Title: Repaired North Elevation
Agent: Jonathan Chelouka
Scale: 1:50 Date: 05/12/2024
Contact

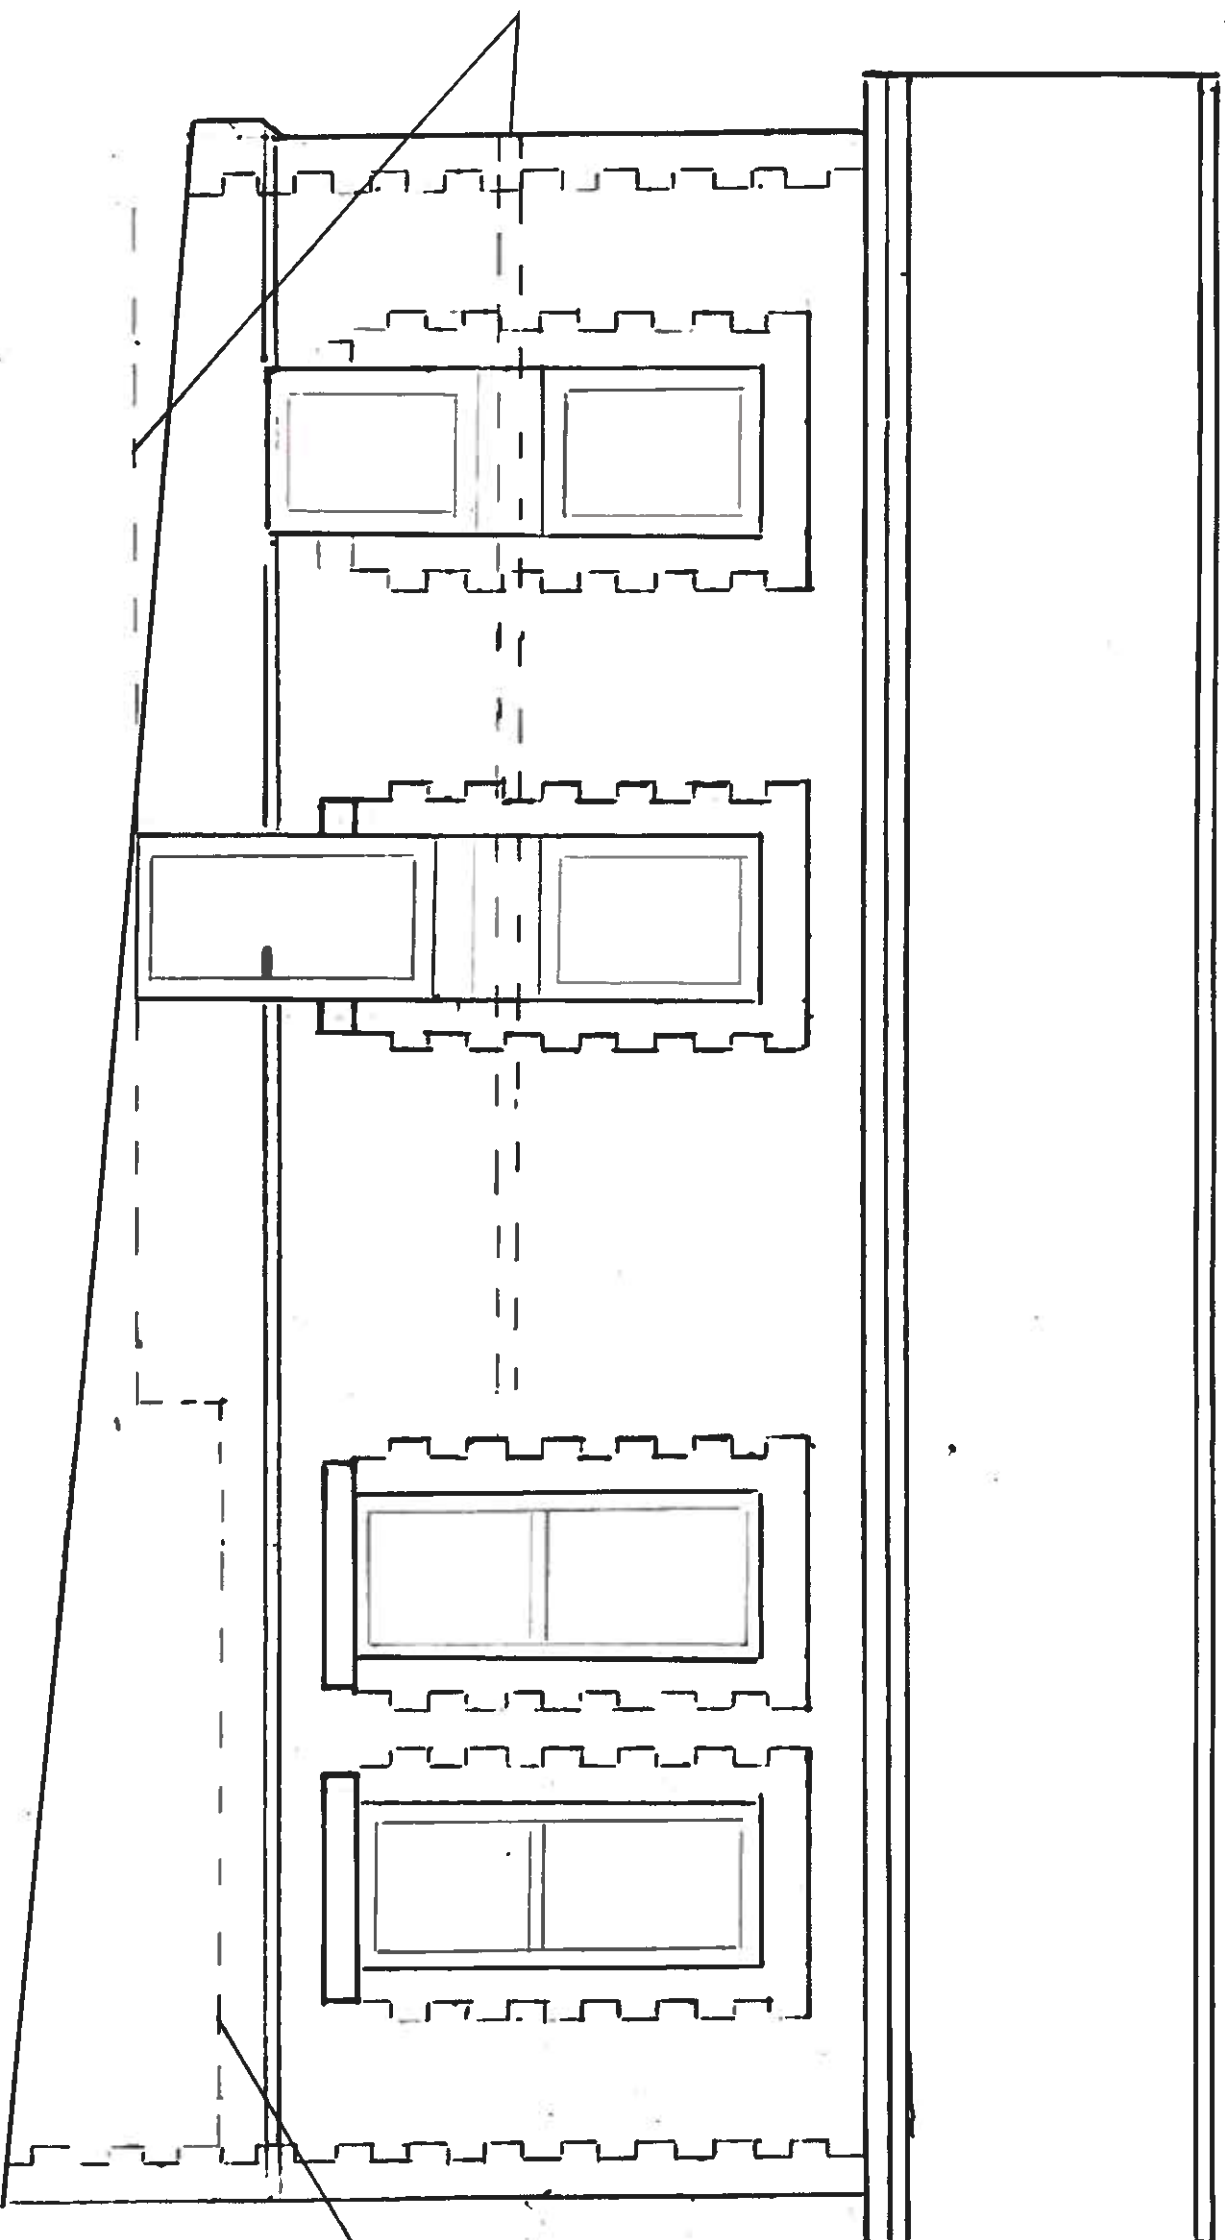
Proposed floor
level for two
story section

Original floor
level

0 Both left hand wove windows to be removed and split to create, on the far left, two windows, one for the ground floor and one for the first floor. and the centre left window will be split to include a patio door on the ground floor and a window on the first floor.
